PARIS#13

PROJECT: PARIS #13		
DESIGN TITLE: BUILT VERSION FINALIZED		
AUTHOR: CH'TI LAMPES	DRAWING NUMBER Drawing_nr	REV: 1F
DATE: 2017-04-02	SIZE: A4	SHEET: 1 of 1

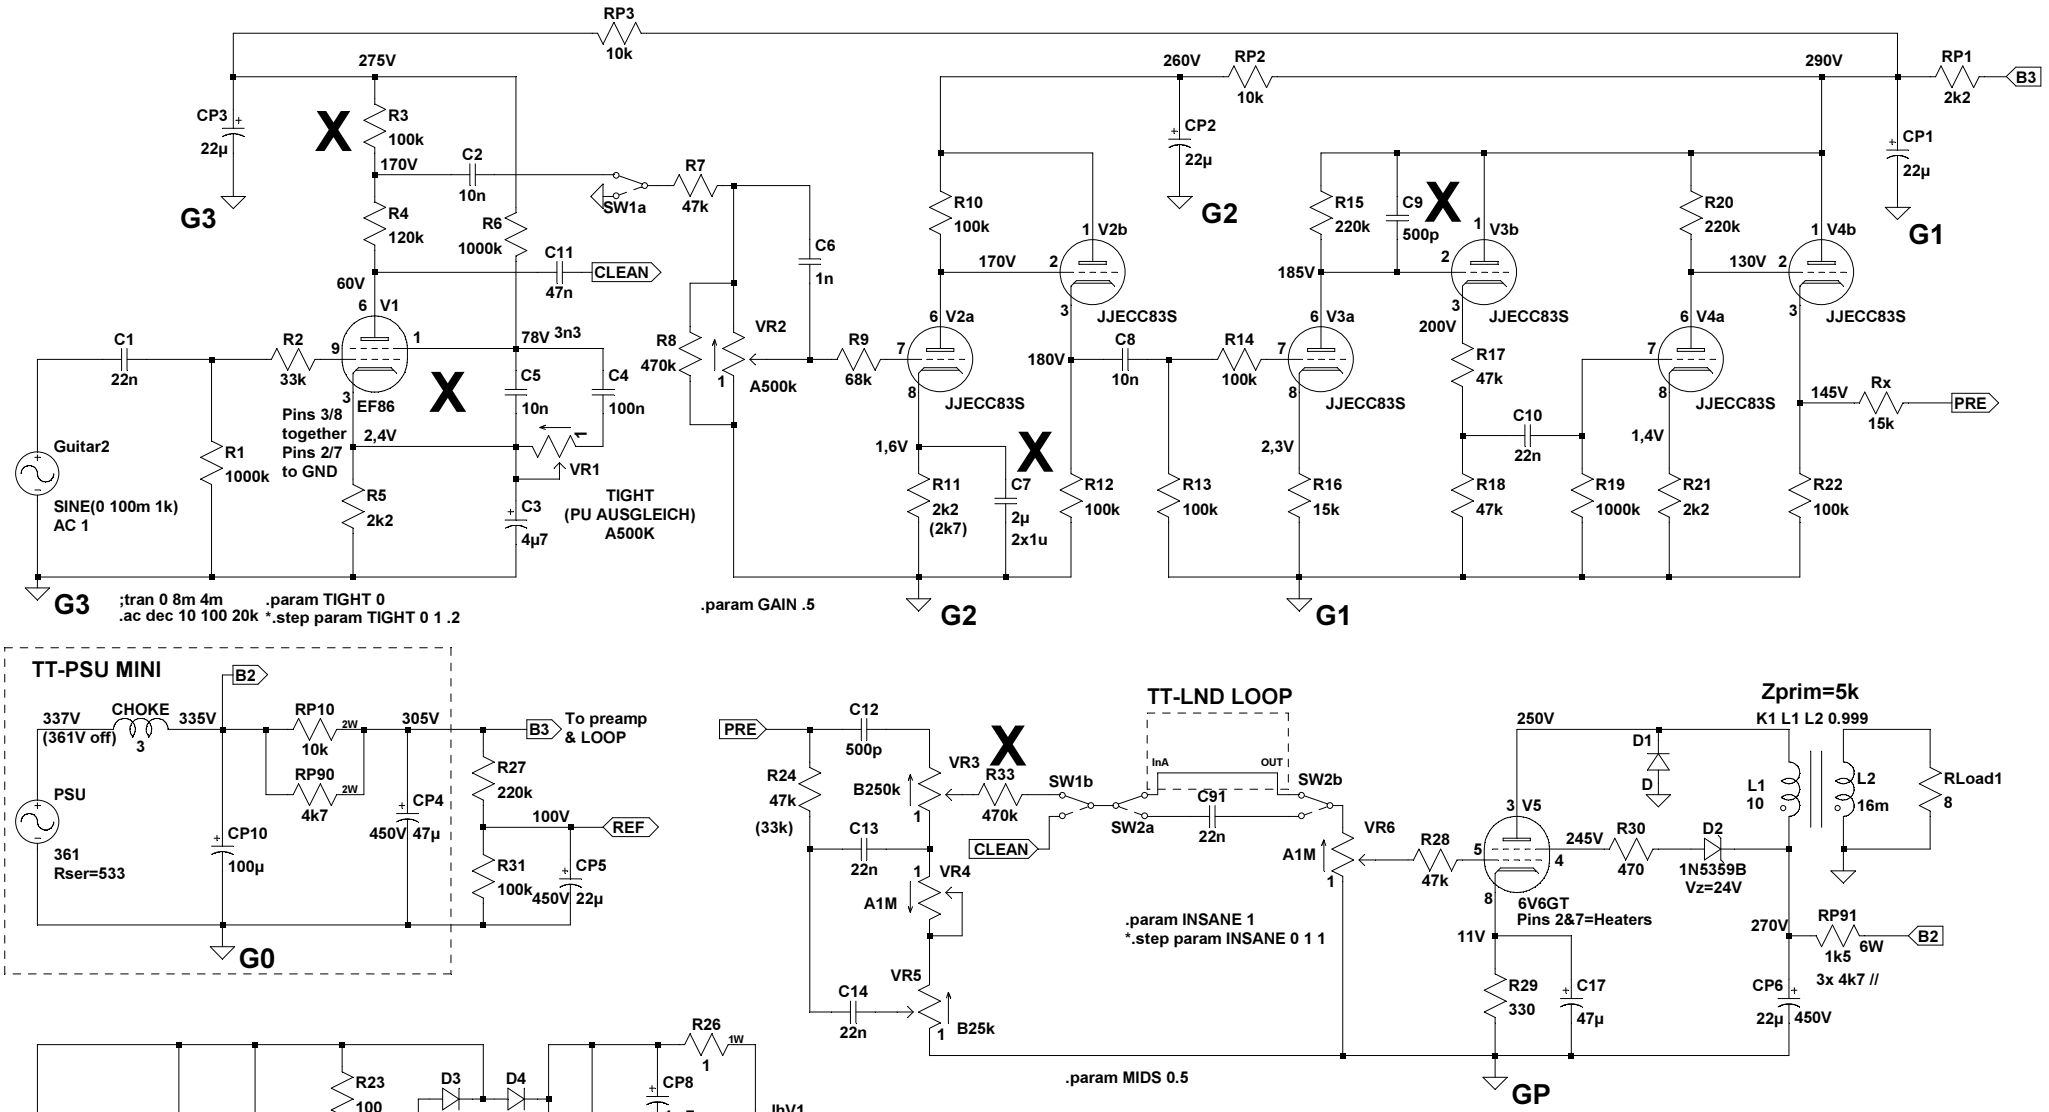
- Removed 500pF over R3
- Removed 100pF at EF86 anode
- Reduced C9 to 500pF
- Reduced singal level of lead channel
- Increased C7 to 2uF (2x 1uF in //)
